## RICE CREEK WATERSHED DISTRICT

### CONSENT AGENDA

September 12, 2001

Purpose: Final Site Drainage Plan and Wetland Alteration Plan for the Shamrock Industrial Park, 4 lots, 19.4± acres.

Location: 045° 08' 50.8" N 093° 11' 08.9" W  
Caption: RCWD Permit Application 01-93

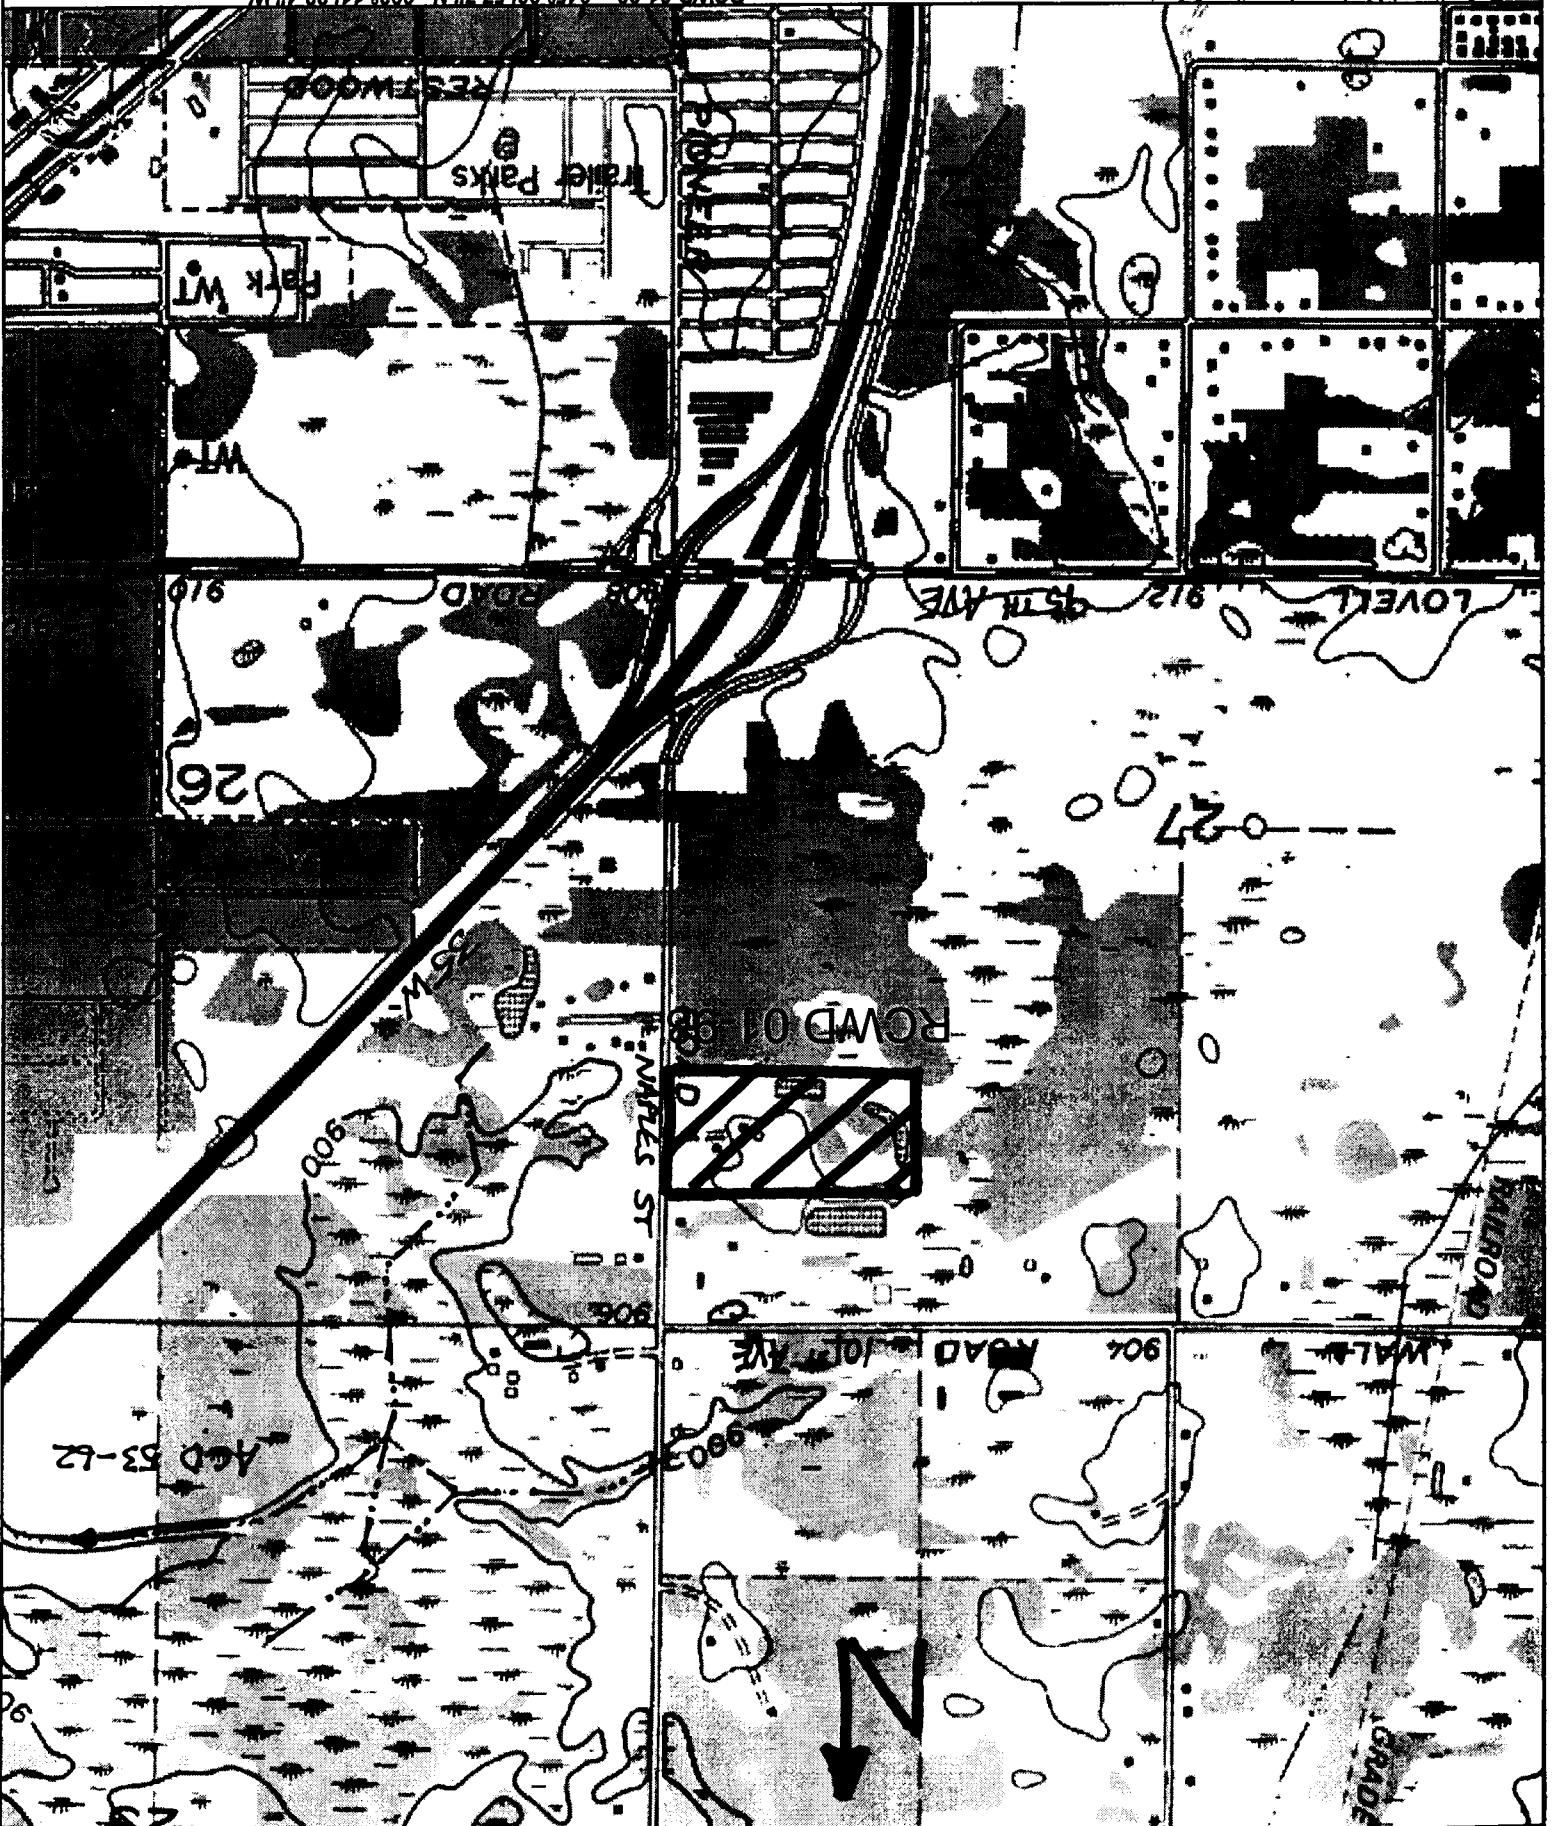
Recommendation: <sup>WAFAN</sup> Table pending receipt of:

1. Revised hydrologic model routing per grading plan and eliminating volume losses in proposed ponds while still demonstrating compliance with District rate control requirements.

2. ~~CONSIDERATION OF ALTERNATIVE METHOD TO ELIMINATE~~  
~~Revised Stormwater Management Plan~~ eliminating short-circuiting potential of Pond 2.
3. Quantification of infiltration area depressed storage.

4. Field verification by District staff of wetland boundaries.
5. Revised plan eliminating Wetland Basin 2 dewatering potential as a result of Pond 2 grading / outlet invert elevation and adjacent stormsewer to Pond 2.

6. Identification of all basin emergency overflow elevations, routes, and stabilization measures
7. Revised first floor elevations (if necessary) complying with District first floor freeboard requirements (per Pending Item 6).

A revised hydrologic model with routing per grading plan and eliminating volume losses in proposed ponds is required before District rate control requirements can be verified.

The three proposed infiltration areas are grassed swales upstream of ponding areas. Quantification of depressional storage is required to verify compliance with District standards.

As currently proposed, Pond 2 in the southeast corner of the site and stormsewer leading to this pond may dewater Wetland Basin 2. A revised plan is required eliminating this dewatering potential.

District first floor freeboard requirements will be verified after approval of the stormwater management plan and identification of all basin emergency overflow elevations.
